SECTION 6

FAILURES IN QUALITY CONTROL

6.1 Introduction

Figure 6.3: Extract from the drawing 1279 (08) 100 Rev 00 'Fire Access Plan' {EXO00000428} contained within the email correspondence between Studio E and Building Control 25.10.2013 {EXO00000427}

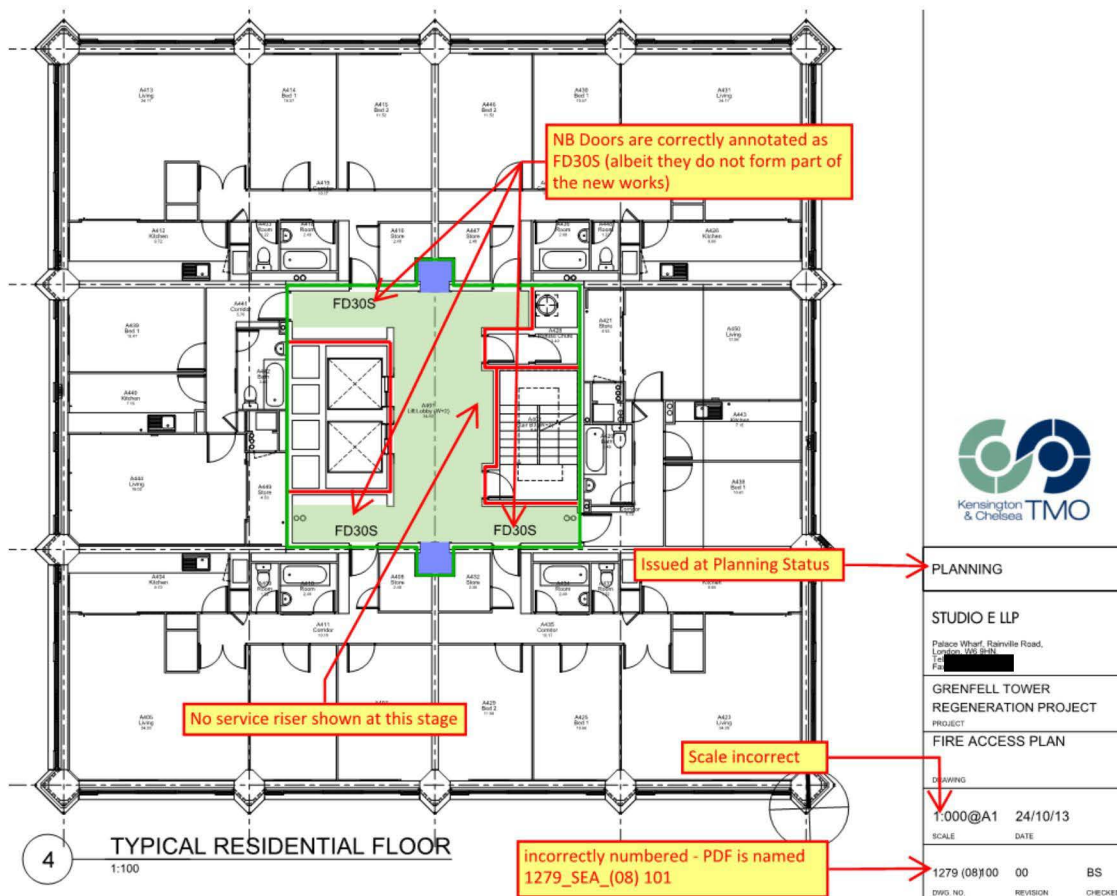
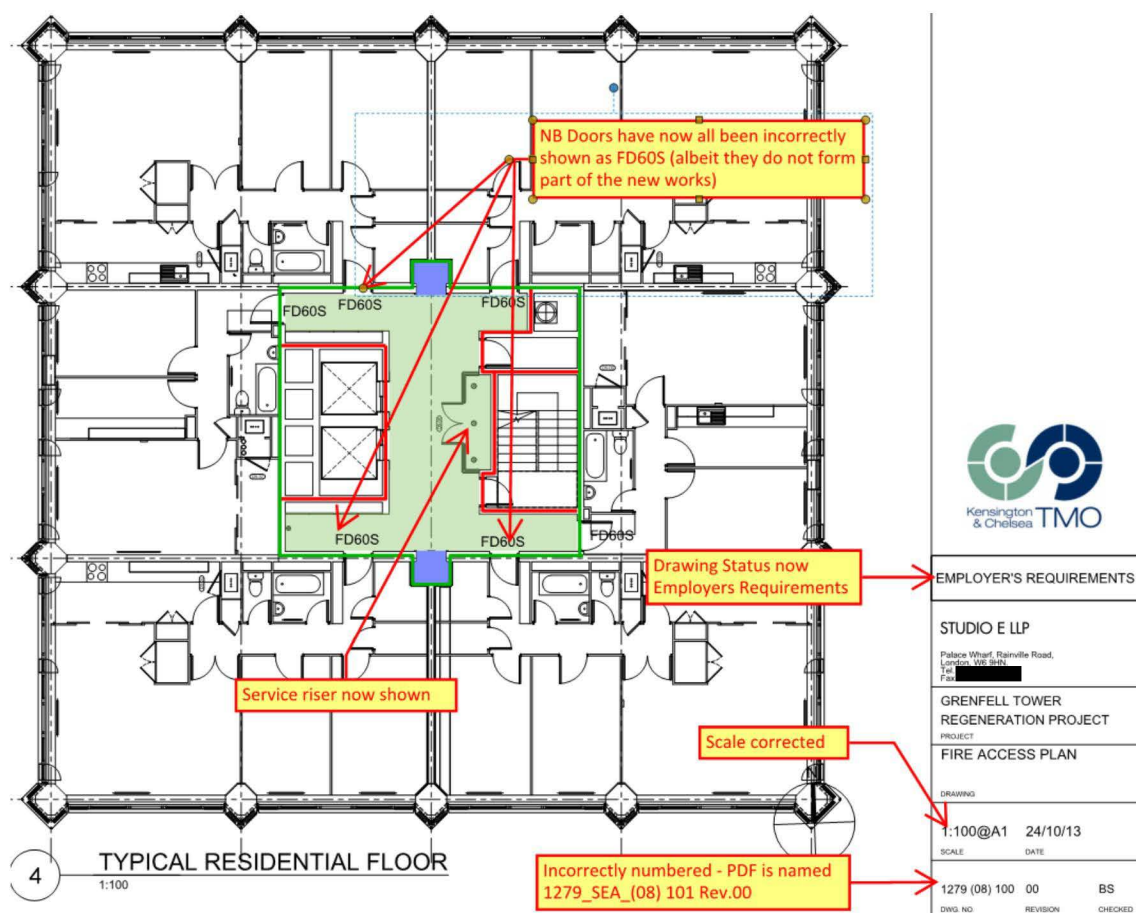
6.4.1 The first two issues of the Studio E Fire Strategy Plans contain errors and anomalies. The two drawings exhibited below, as prepared by Studio E, have been annotated to show examples in this respect:

Figure 6.5: Extract from the drawing 1279 (08) 101 Rev 01 'Fire Strategy' {RYD00018761}

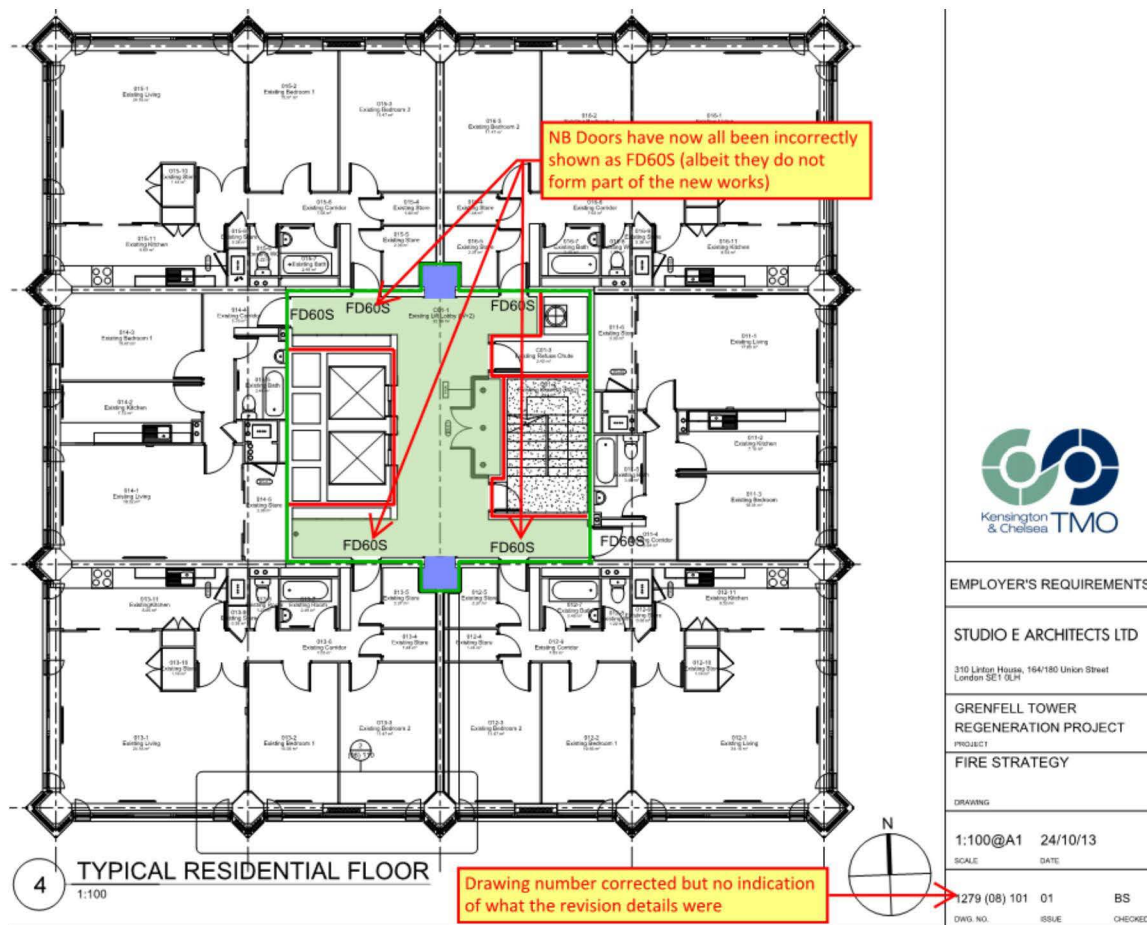
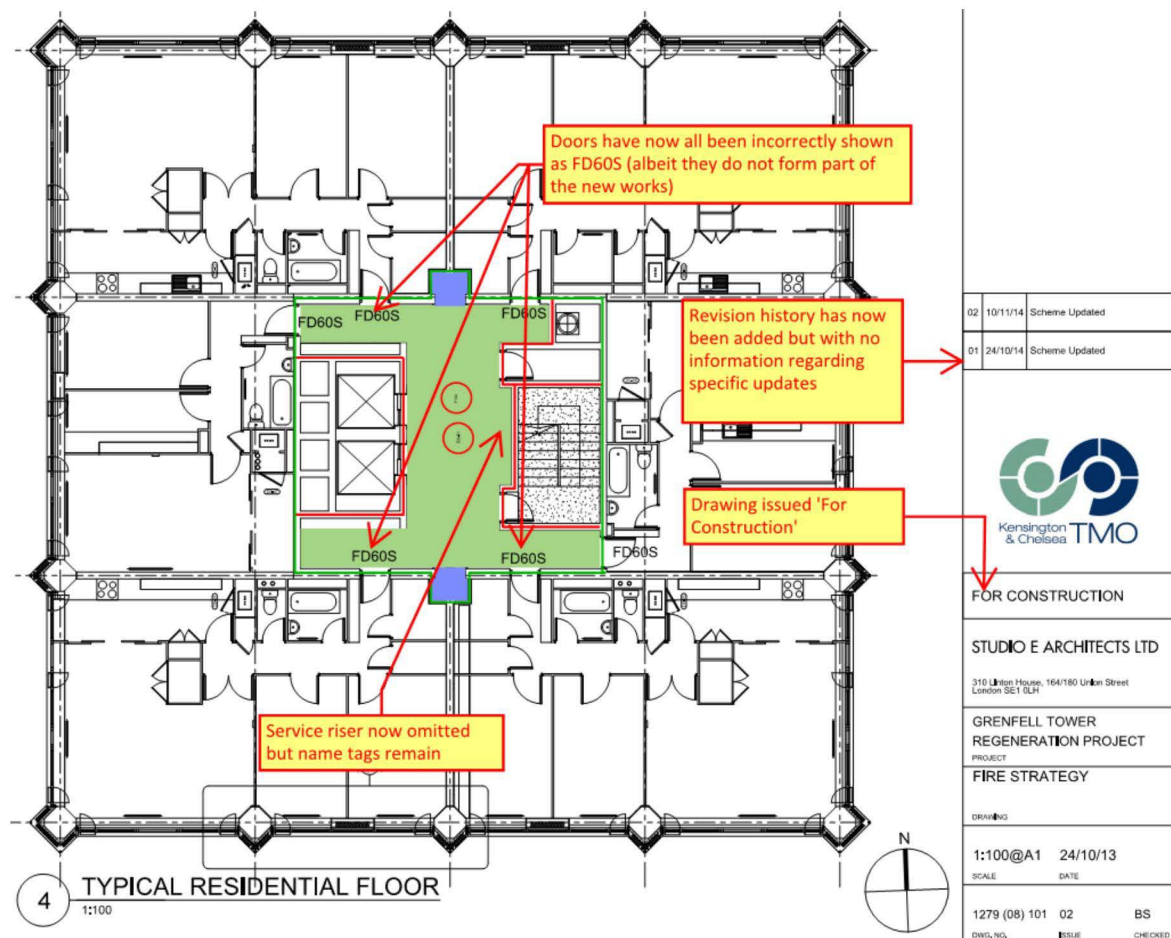
6.4.2 The next two issues of the Studio E Fire Strategy Plans, as exhibited below, contain a series of corrections but also introduce some further errors and omissions which have been highlighted in yellow. These errors and omissions continue unamended through to the Issue 5 'As Built' version of the drawings.

- 6.4.3 It is also notable that within Figure 6.6 although the revision note has been included (see above drawing title box), the changes that have been made under that revision have not been recorded. The revision description merely states '*Scheme Updated*'. Normal protocols with respect to revisions are for the revision to be described, albeit briefly, in the space adjoining the revision number above the title box, and for the drawing for that issue only to be annotated with a '*balloon*' around the revision or revisions that clearly highlights the amendment. This simple and widely adopted protocol was not generally adopted for the over-cladding drawings, albeit Studio E did adopt it extensively elsewhere for the 2012-16 Works. As a result, there was usually no indication and/or location to notify recipients of the drawings as to what specific changes had been made.

Figure 6.13: ‘As Built’ drawing (04) 202 Revision A {RYD00000435} (page 13 of document) and at {SEA00003419}

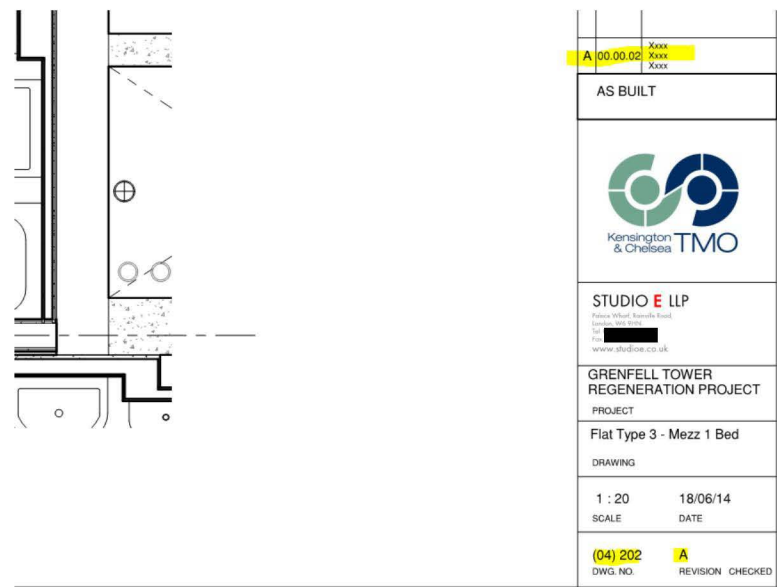
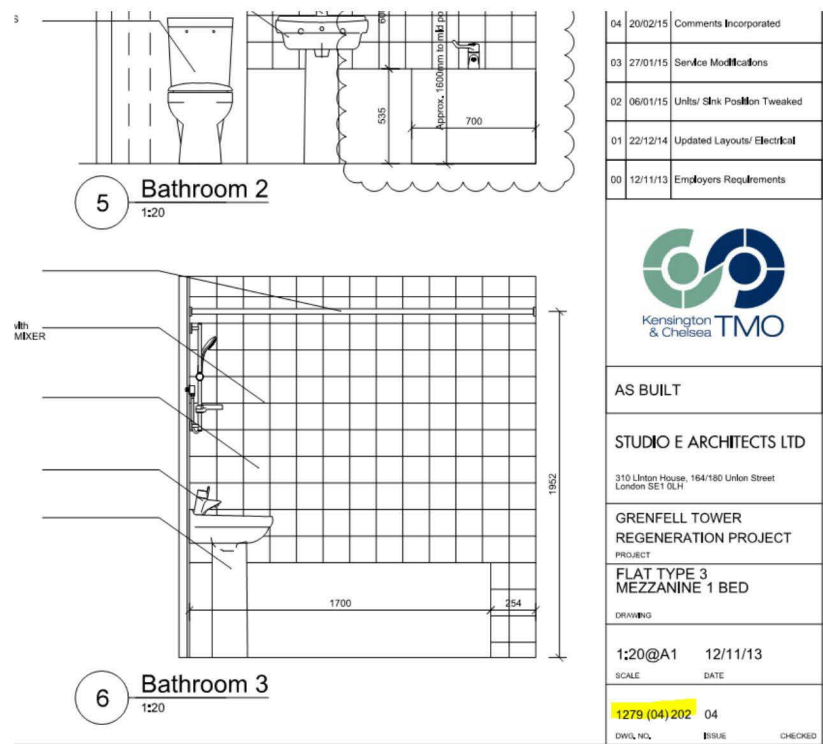
6.6.9 This example, exhibited in the two drawings below, reveals confusion in drawing numbering: two completely different drawings have been registered and issued with the same drawing number.

6.6.10 The first exhibit, Figure 6.13, (title '*Flat Type 3 – Mezz 1 Bed*') is referenced drawing number '*(04) 202 Revision A*', as is the second exhibit, Figure 6.14, which carries the same title ('*Flat Type 3 – Mezzanine 1 Bed*') and the same drawing number albeit with a '*1279*' prefix and carries '*revision 04*'

6.6.11 Scrutiny of these drawings reveals that they contain entirely different images and information: despite carrying the same number they are different drawings which, it seems, existed concurrently albeit providing information on quite separate subject matter.

6.6.12 Such confusion around drawing numbers and identity is, for obvious reasons, completely untenable: these drawings were in currency from, respectively, the 12 November 2013 and 18 June 2014 – and were concurrent for the period 18 June 2014 onwards. At their point of issue under the '*As Built*' release on the 23 May 2016 that concurrency had extended to some 23 months.

6.6.15 The following irregularities are also notable on the exhibits below:

- a) There is no initial in the '*checked*' part of the drawing title block for either drawing – a frequent failing across Studio E drawings.
- b) The revision section of the first exhibit – as highlighted - carries no date or description of whatever constituted revision A.

The revision section of the second exhibit shows some four revisions listed in orderly fashion across a timespan of four months, which means that those on the distribution list each had opportunity to identify the concurrency issue upon receipt albeit I would not necessarily expect the recipient to spot the error.

Figure 6.15: Drawing 1279 (06) 120 Rev 00 – ‘Detail Section Sheet 1’ {RYD00000435} (page 27 of document) and at {SEA00003436}

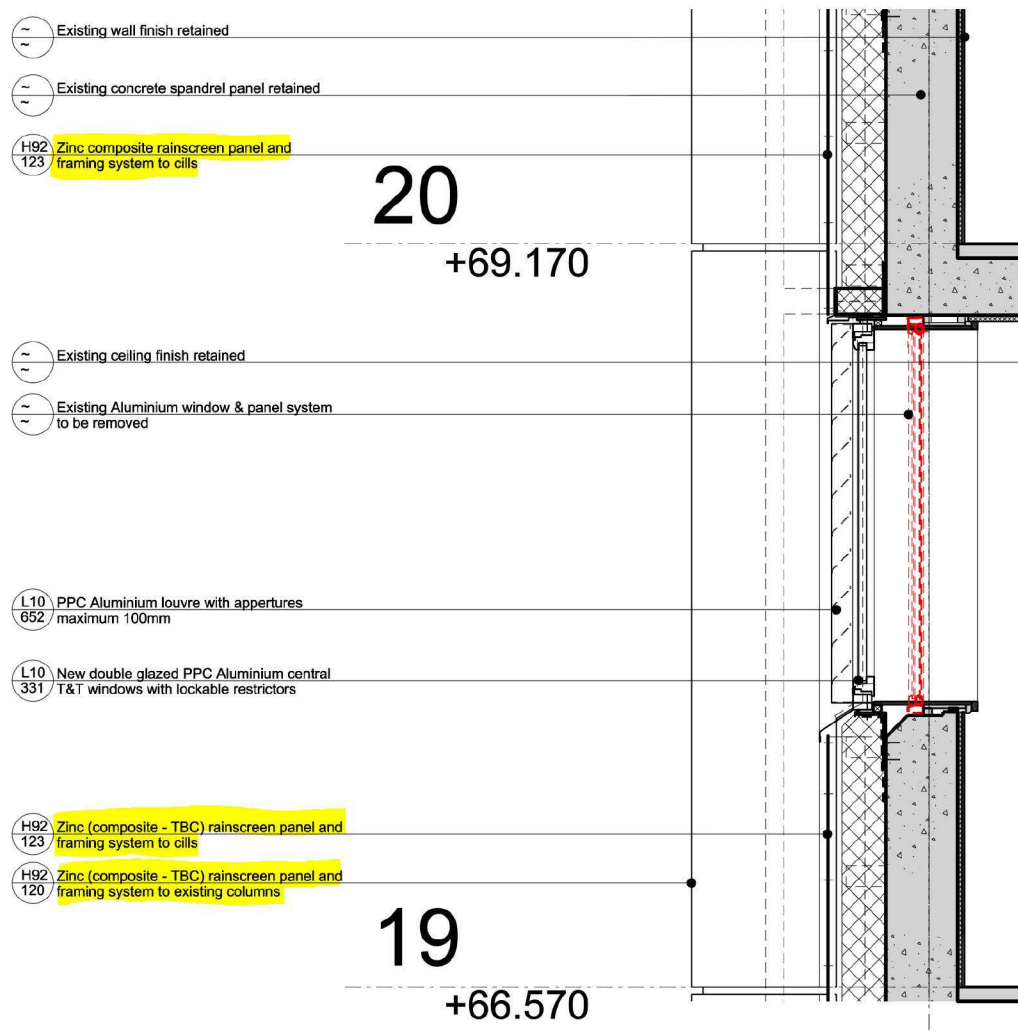
- 6.6.16 This example reveals errors in specification referencing. It relates to incorrect referencing of the rainscreen cladding material. There are numerous instances where the rainscreen cladding has been identified as zinc composite as highlighted in the exhibit below (when of course, as has been shown throughout Sections 4 and 5 of this report, the zinc proposition was abandoned in favour for ACP).

- 6.6.17 That an error of this kind, in respect of a component as major as the cladding material of the entire building could be misdescribed over such a sustained period in the development of the production information is clear evidence that routine Quality Assurance checking and review procedures, as required under ISO 9001 registration, were either not carried out at all, or in the alternative, were not carried with reasonable competence.

- 6.6.18 The drawing exhibited below began its *'life'* as one of the *'Employer's Requirements'* set (Snap-Shot 2 stage) and is still current as part of the *'As Built'* record.

Figure 6.16: Extract from Drawing 1279 (70) 100 Rev 05 – 'Fire Strategy' (Typical Residential Floor) {RYD00000435} (page 31 of document)

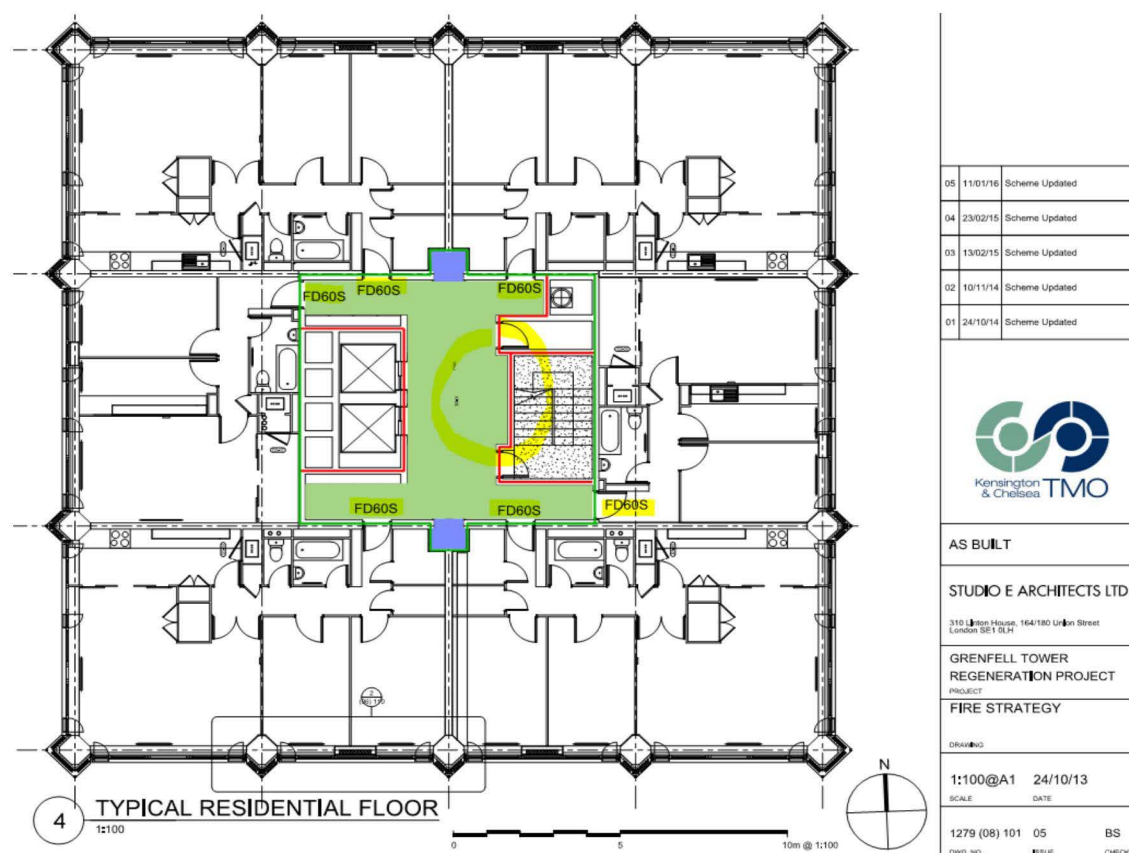
6.6.23 I list below a series of serious and fundamental errors that are manifest within the drawing exhibited at Figure 6.16 {RYD00000435}:

- a) The front doors to the flats are denoted as being FD60S. This stands for '*fire door 60 minutes with smoke seal*' which means that the door will perform against set standards in terms of providing a level of protection to the public areas from fire and smoke arising from a fire incident within a flat.

- b) In this instance these doors (that is front doors from the 4th – 20th floor) did not form part of the 2012 – 2016 Works.
- c) Furthermore, most of these doors had been upgraded under a separate contract (in which Studio E had no involvement) that had been carried out shortly before the 2012 – 2016 Works were carried out. In order to comply with the guidance in ADB2 these front doors were only required to achieve FD30S standard.

- d) There are serious questions (fully addressed in Dr Lane's report) as to whether the replacement doors installed before the 2012- 2016 Works actually achieved compliance in all cases with the FD30S standard. That is not a matter for this report, but it is relevant to this review because Studio E are seen here to be providing misinformation of the most serious kind. The drawings imply at the least that the ADB2 guidance had been significantly improved upon in relation to the fire performance of the front doors but they could also be misinterpreted by Building Control Officers and the Fire Department to be an indication that new upgraded doors were to be installed under the 2012-2016 Works.

- e) In circumstances where the recently replaced front doors were of questionable quality in terms of compliance with the minimum standard set by guidance, which as Dr Lane's report reveals was indeed the case, any drawings which carry information implying that front doors have been or are to be upgraded to FD60S potentially generate serious confusion around an issue that should never be subjected to any confusion whatsoever.

- f) I have used yellow circle on Figure 6.15 to highlight an area opposite the lift which denotes that under its process of amendment Studio E, obviously inadvertently, deleted the enclosure of the service riser duct; that is, the partition and doors that formed it against the wall adjoining the fire escape stair. This is a serious omission/mistake: service ducts are high-risk areas as they enclose area where services are passing through compartment floors.

- g) Whilst there are strict requirements in terms of sealing around the services as they pass through floor it is an important part of any fire safety strategy that the riser enclosure, that is the '*cupboard*' through which they pass, is itself constructed of materials and components (wall and doors) which combine to provide the level of fire protection set out as guidance in ADB2. This enclosure was missing in the fire strategy drawings.

- h) Here we have an example of '*sloppy*' drafting omitting the entire services '*cupboard*' enclosure. The significance of such an error can hardly be overstated. As stated earlier, errors are inevitably made, but that such an error could remain on a drawing over such a long period and indeed even be carried into the '*As Built*' record set and O&M manual is unacceptably lax.

- i) It is also to be noted in the revision box that revisions are recorded as '*Scheme Updated*'. Normal convention is to provide at least a simple narrative that is indicative of change and I am critical of Studio for failing to do this because such information is useful to those involved in quality checking as it guides them swiftly to the point of change.

Figure 6.17: Drawing 1279 (70) 100 – ‘Entrance Lobby Light Set out’ {RYD00000435} (page 54 of document) and at {SEA00003434}

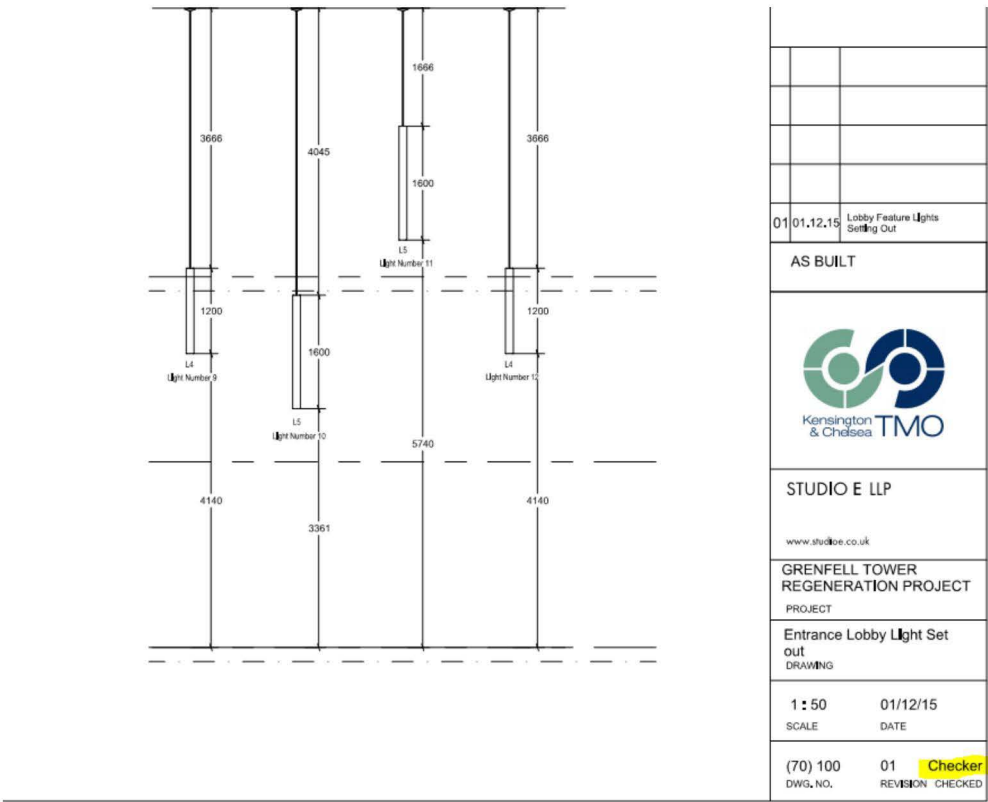
6.6.24 This example relates to another failure in the maintenance of the Drawing Register. In this instance a drawing has been prepared and issued, on this occasion as part of the 'As Built' record set, but the drawing is simply not recorded on the register.

6.6.26 My overall impression is that there was a 'sloppiness' in the way in which the 'As Built' register was compiled and maintained.

Figure 6.18: Kompan Kensington Academy and Leisure Centre ‘Proposed Play Area’
 {RYD00000435} (page 62 of document)

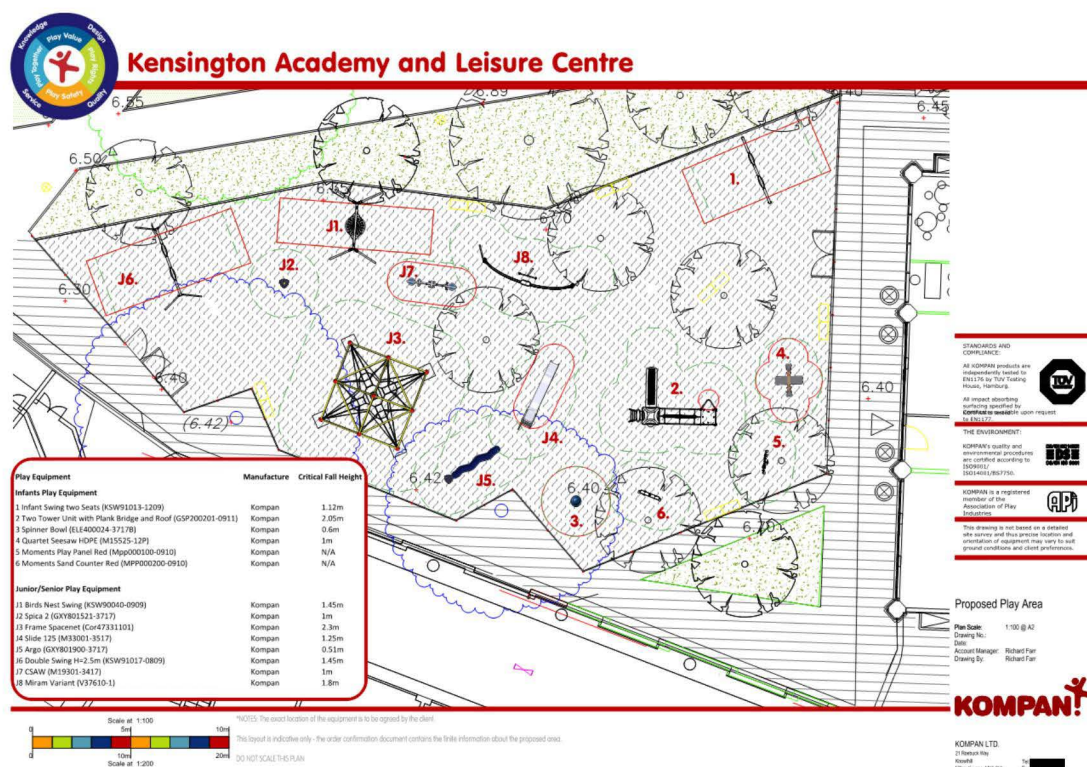
6.6.28 However, the exhibit below at Figure 6.17 shows a drawing from another project by another firm.

6.6.29 I have no idea how a drawing for another project by another consultant could ever get into the Studio E 'As Built' record set that represents the Grenfell Tower project. That said, little turns on this drawing, which relates to trees and landscaping somewhere else but again, it is indicative of poor checking processes.
